# RotorSport UK Ltd Service Bulletin (Permit)

<b>Title: Calidus MTOW increase to 560Kg</b>		<b>Release date 17.05.2020</b>
<b>SB-134 Iss1</b>	<b>Related documents</b> Modification: CCAR No.: None	<b>Compliance Category:</b>
<b>Applicability</b>		<b>OPTIONAL</b> <del>or</del> <b>RECOMMENDED</b> <del>or</del> <b>MANDATORY</b>
<b>Aircraft type &amp; model:</b> Calidus	<b>Aircraft serial Nos. affected:</b> All with 3mm suspension bow bracket and 914UL engine	
The maintenance manual to be referenced is this stated or subsequent issue.		None
<p>This form is the response from RotorSport UK Ltd either against a problem found in the product in service requiring a containment or rectification action, or as service information for aircraft modification incorporation. For help, contact RotorSport on 44(0)1588 505060, or email <a href="mailto:compliance@rotorsport.org">compliance@rotorsport.org</a>.</p> <p>The technical content of this document is approved under the authority of the UK CAA Design Organisation Approval Ref: <b>DAI/9917/06</b></p>

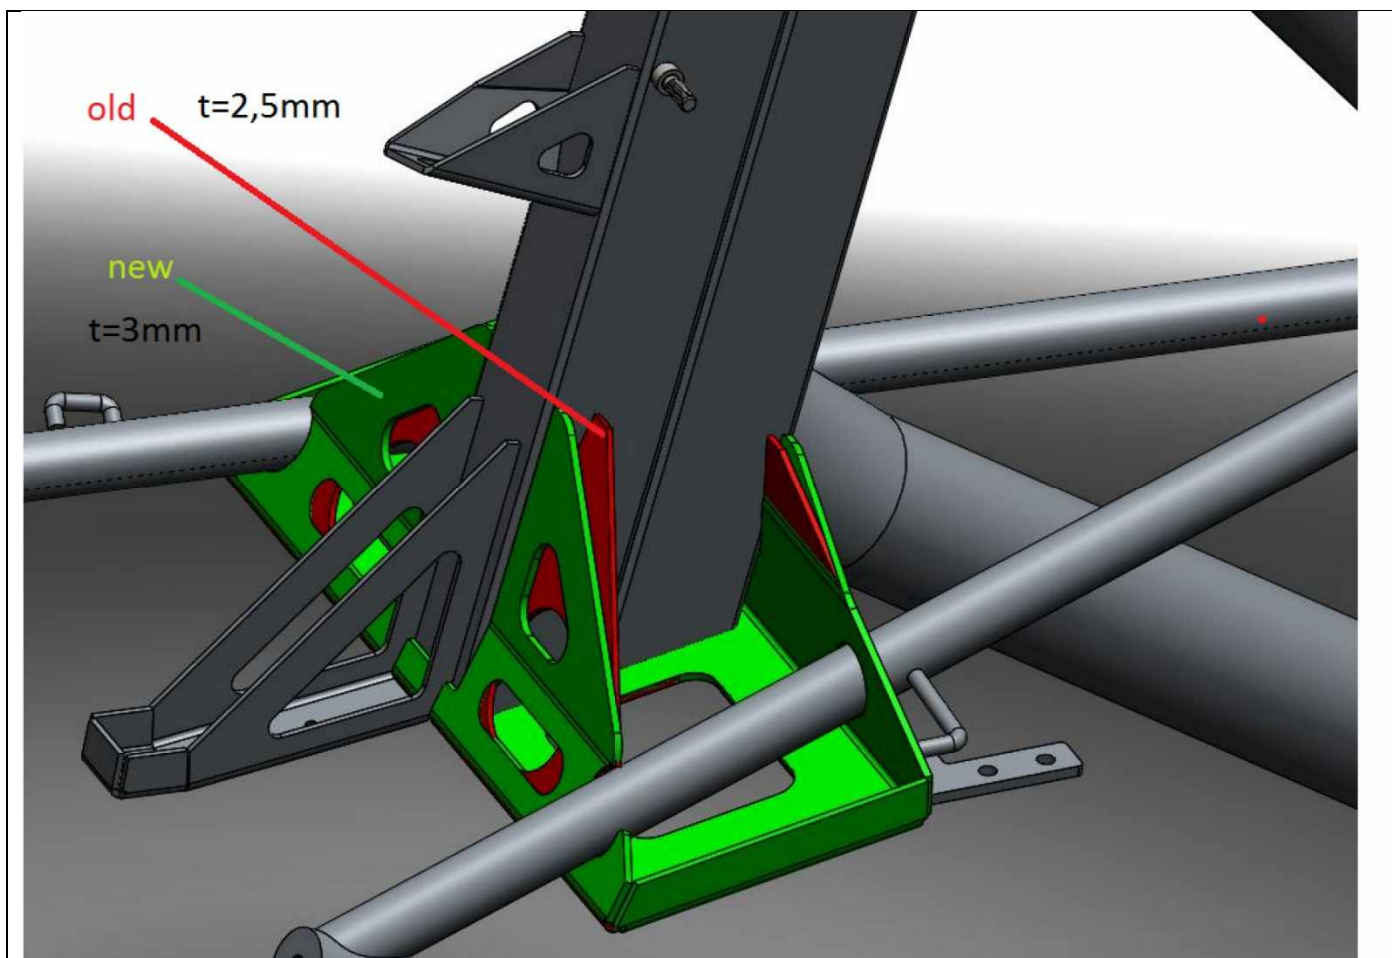
This change is only applicable to Calidus aircraft fitted with 914UL engines and with the suspension bow bracket thickness of 3mm (from approx. serial number RSUK/CLDS/028)

1. Measure the thickness of the suspension bow bracket. If 3mm, proceed. If 2.5mm this bulletin does not apply. See picture.

2. If 3mm, complete the logbook requirements.
3. Complete the permit change document and send to the UK CAA
4. On receipt of the CAA updated documents, change the placarded MTOW from 500Kg to 560Kg.
